Re: Booth Snead Drain, 126th Street Arm

Re: Mud Creek – Sand Creek: Booth-Snead Drain: 126th Street Arm

Attached are as-builts, certificate of completion & compliance, and other information for Booth – Snead: 126th Street. An inspection of the drainage facilities for this section has been made and the facilities were found to be complete and acceptable.

126th STREET - LINE "PR-2-A"
CONSTRUCTION DETAILS

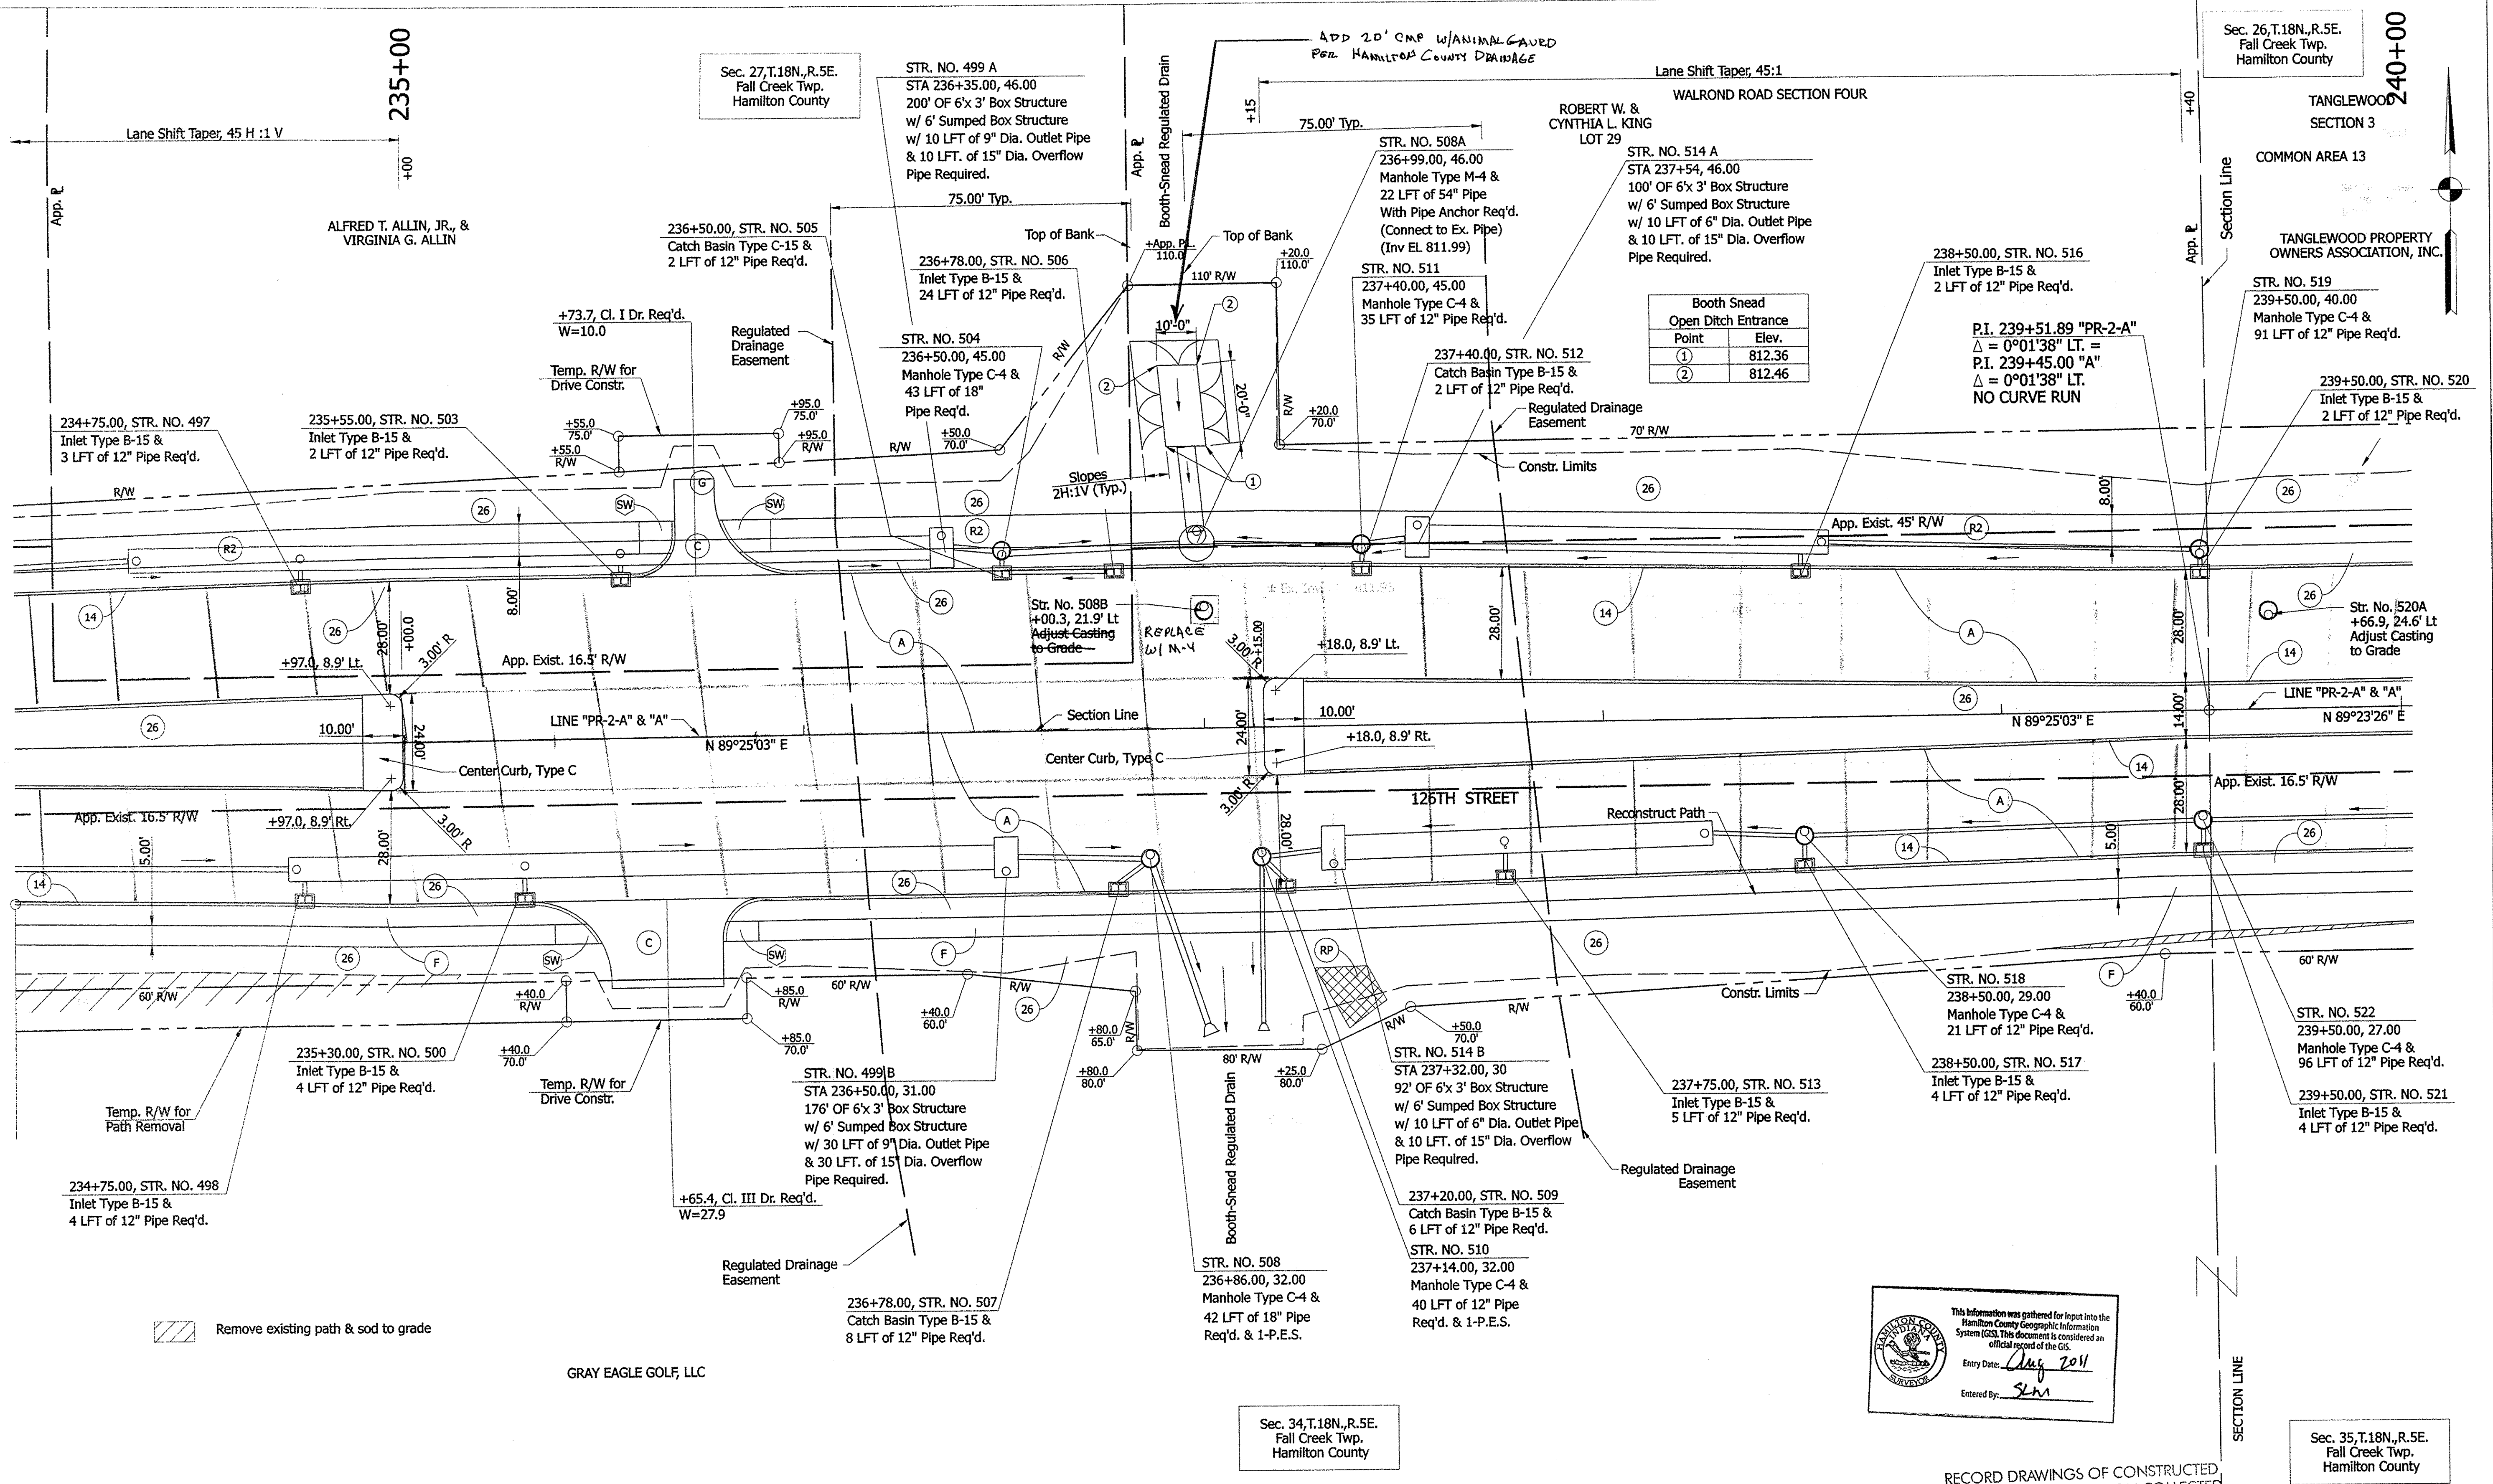
During construction, changes were made to the drain, which will alter the plans submitted with my report for this drain-dated March 4, 2009. The report was approved by the Board at the hearing held March 9, 2009. (See Drainage Board Minutes Book 11, Page 516)

The project removed an additional 10 feet of the original Booth- Snead tile and replaced it with open ditch. The original tile was removed from Sta. 17+39 to Sta. 17+71. The length of the drain due to the changes described above is now **32 feet**.
